CONSTRUCTION PLAN FOR:

CONTRACT NUMBER 82-073-05

REHOBOTH AVENUE BRIDGE NO. 153

1-15-87 AS BUILT PLANS P.K. E.I.

CONSTRUCTION PLAN - DETOUR
STA. DR 52+00 TO STA. DR 57+75

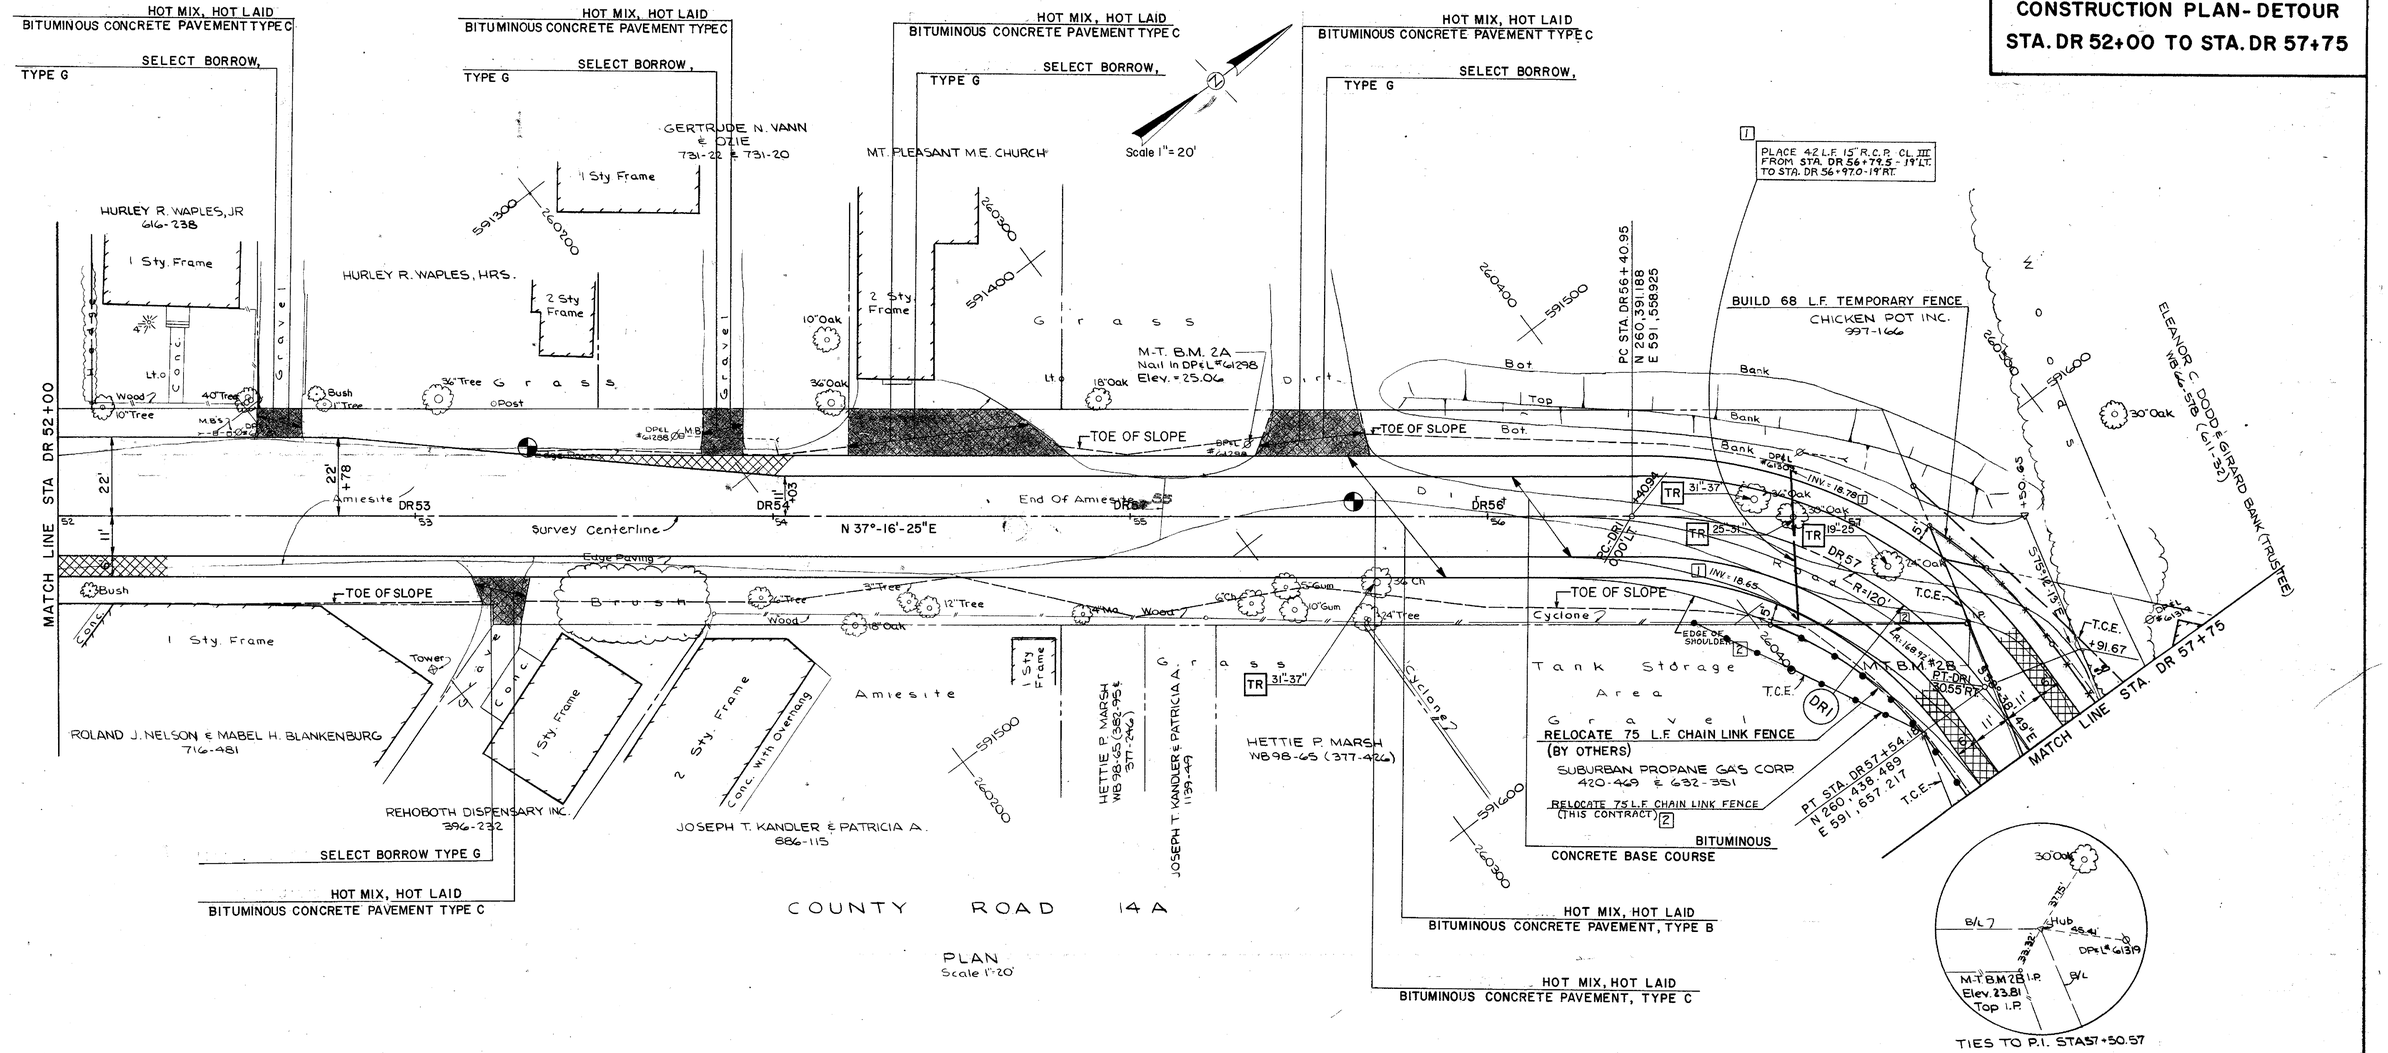
REVISIONS
1 Added cross road pipe 12/6/94 JMSJH
2 Added widening on inside of curve & superelev. on outside of curve 4/23/95 JMSJH

CONSTRUCTION PLAN - DETOUR
STA. DR 57+75 TO STA. DR 62+25

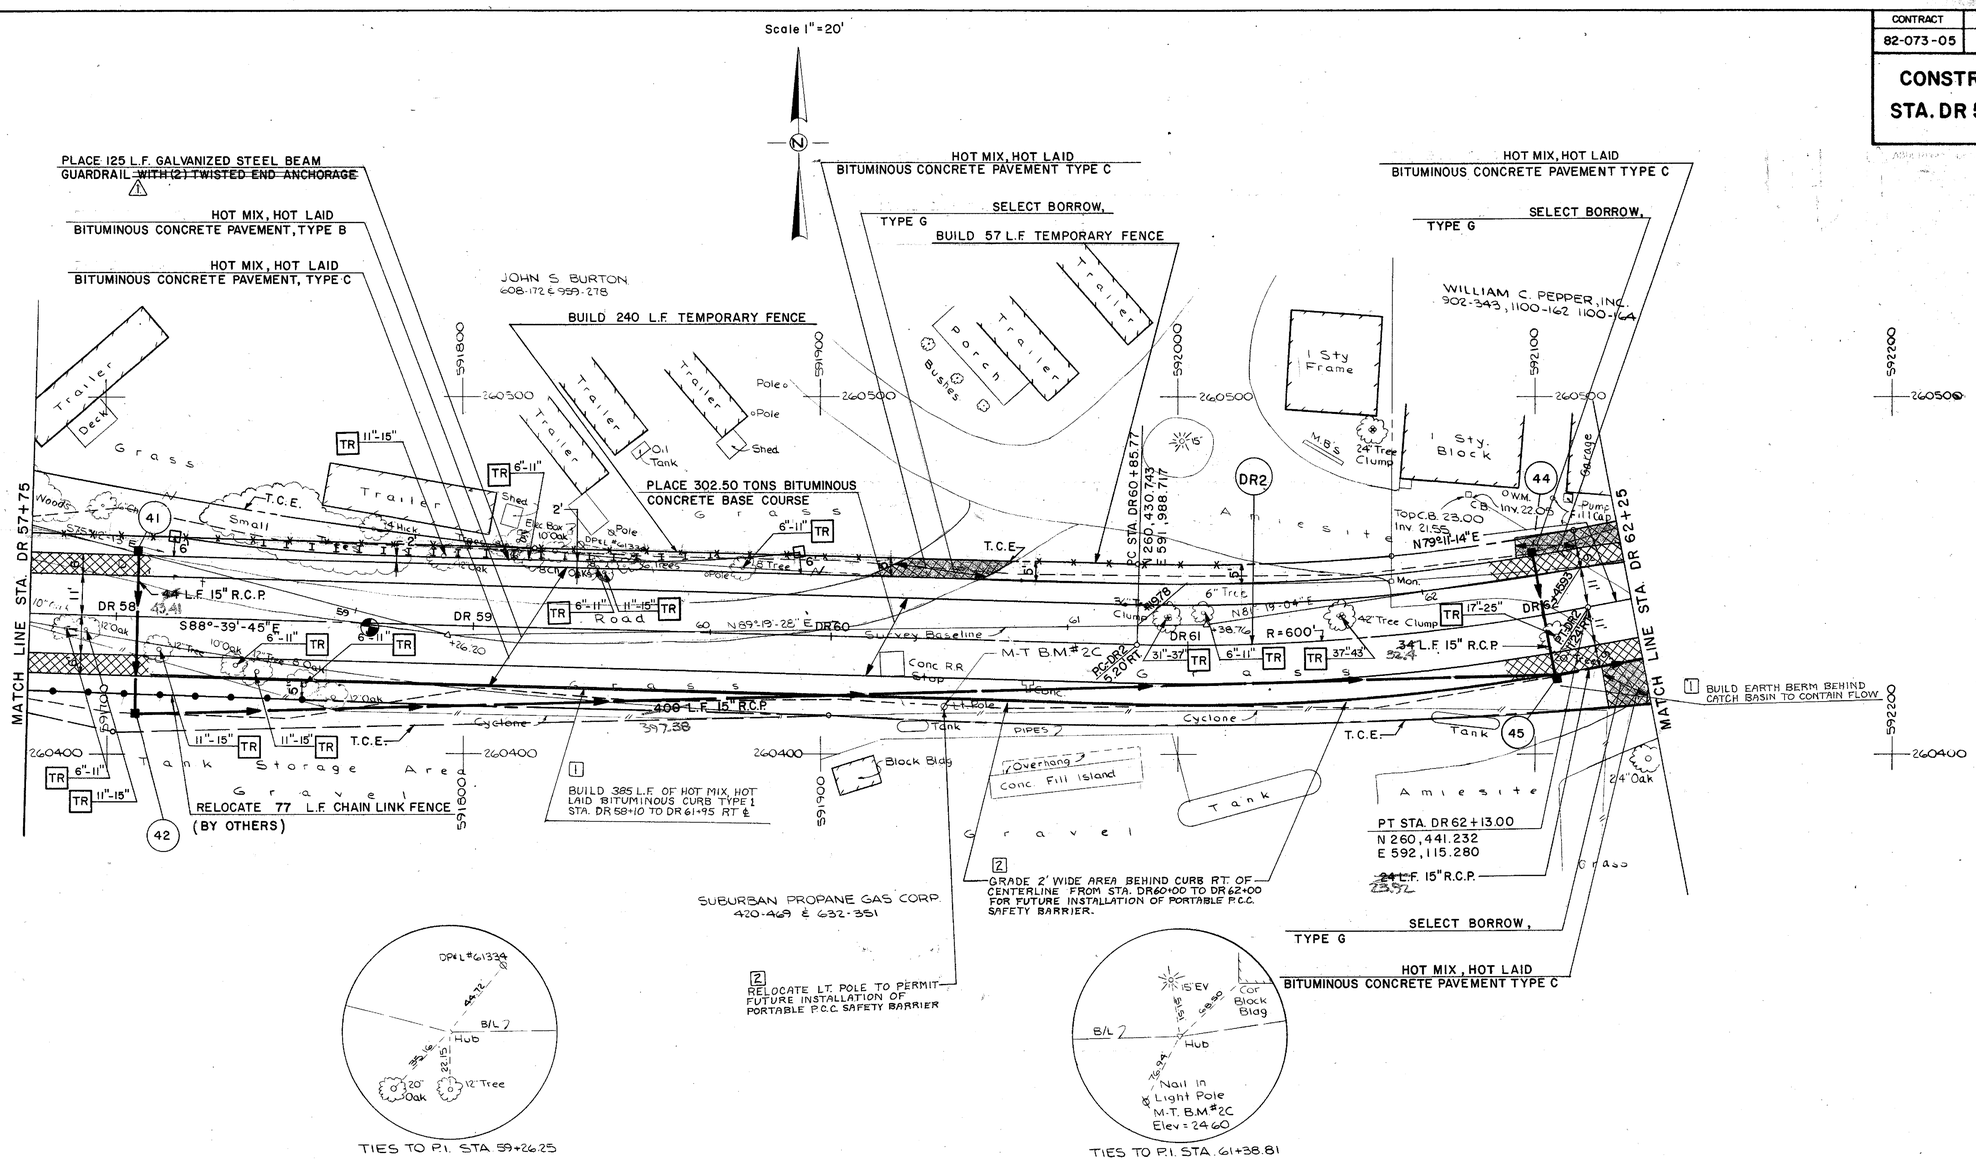
△ ADDENDUM #2 - DELETED T.E.A.'S JMSH. 9/24/04
1 REVISION - ADDED HOT MIX CURB JMSH. 11/5/04
2 Added a pole relocation & grading 4/25/05 JMSH.

CONSTRUCTION PLAN - DETOUR
STA. DR 65+75 TO STA. DR 72+00

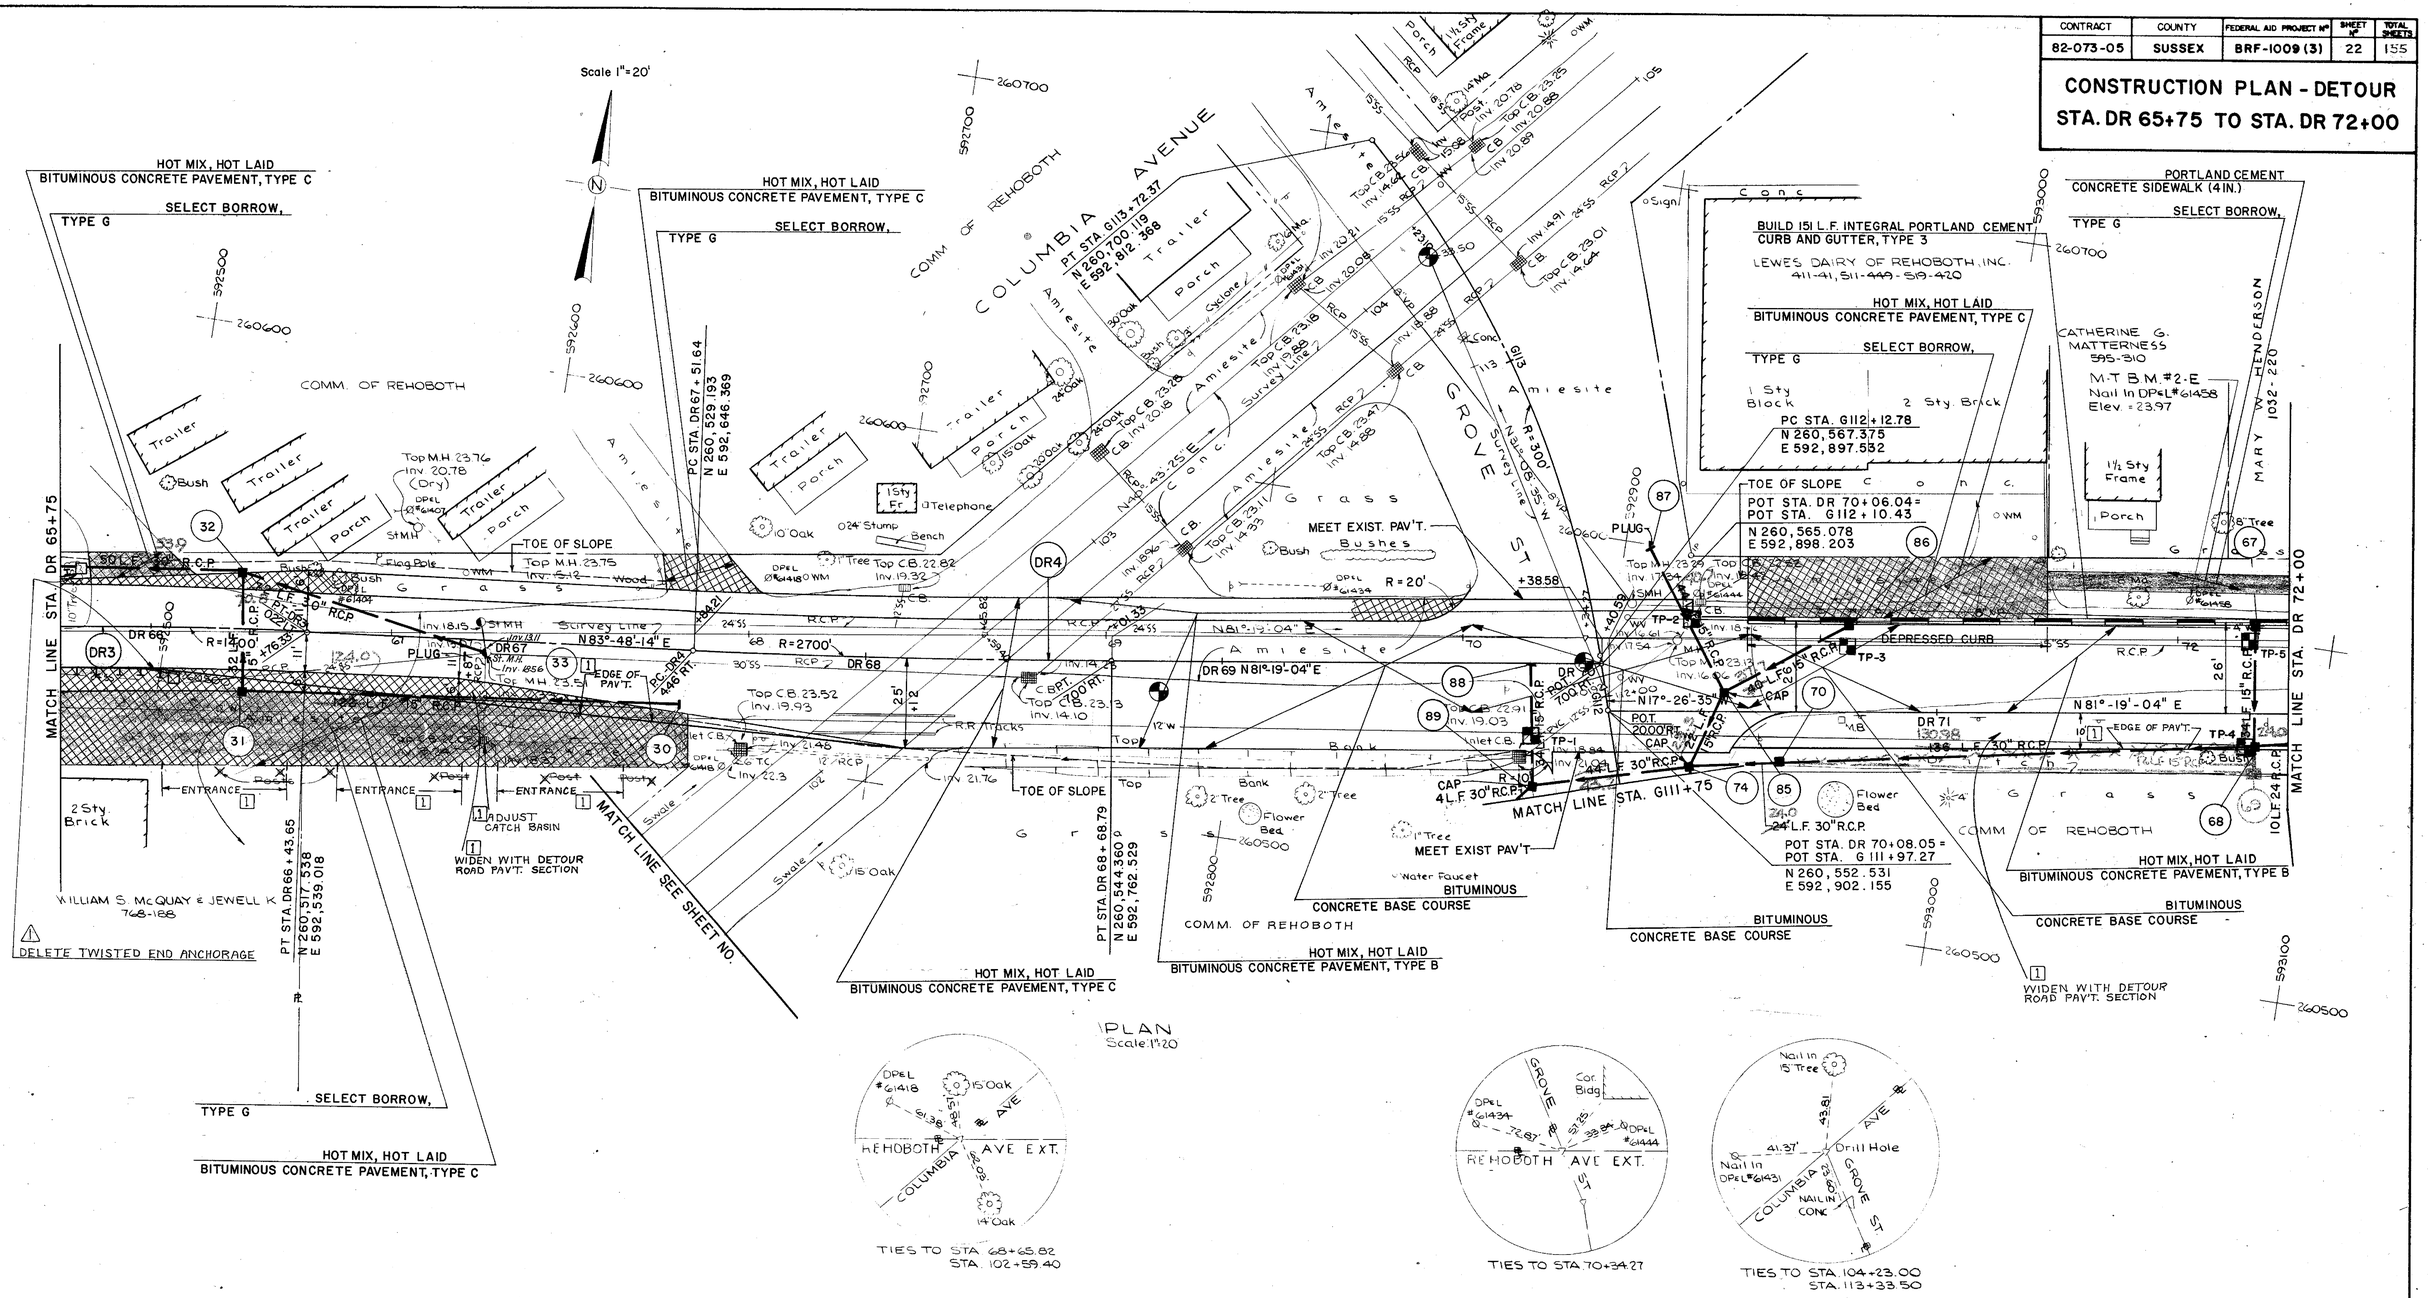
REVISIONS
1 ADDENDUM Nº2 - DELETED T.S. A/S JMSch. 9/26/06
2 Defined entrances, guidewall detail 4/21/05 JMSch.

CONSTRUCTION PLAN - DETOUR
STA. DR 72+00 TO STA. DR 75+00

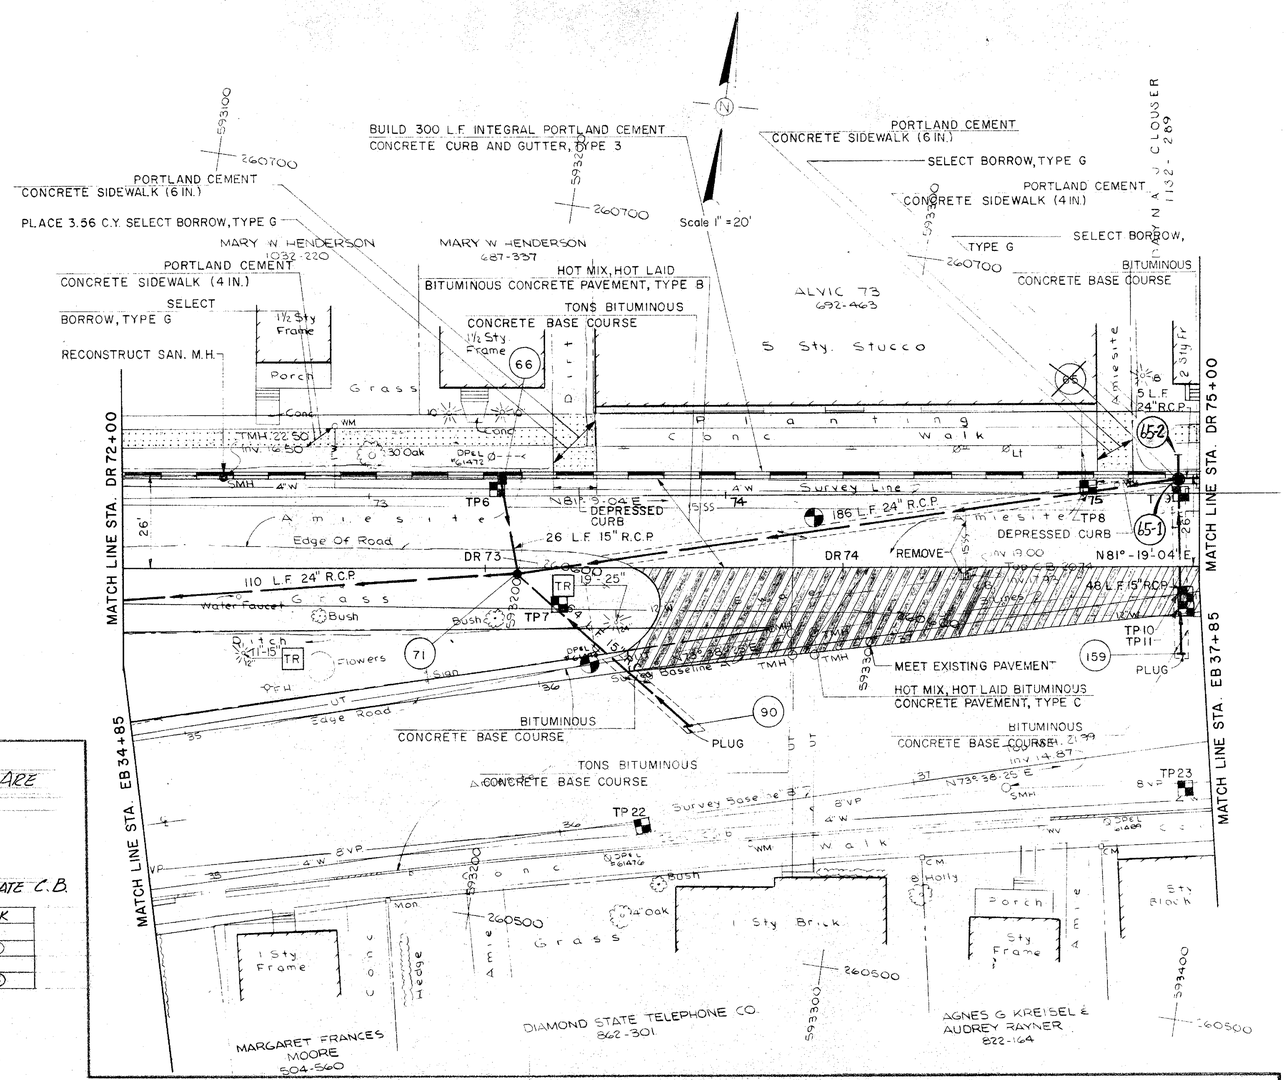
THESE TWO SHEETS (D23, D24) ARE FOR DRAINAGE CHANGE ONLY

A. ELIMINATE PIPES

C. ADD M.H.

D. ADD C.B.

E. ADD PIPES

F. CHANGE PIPE CONNECTING MARKS
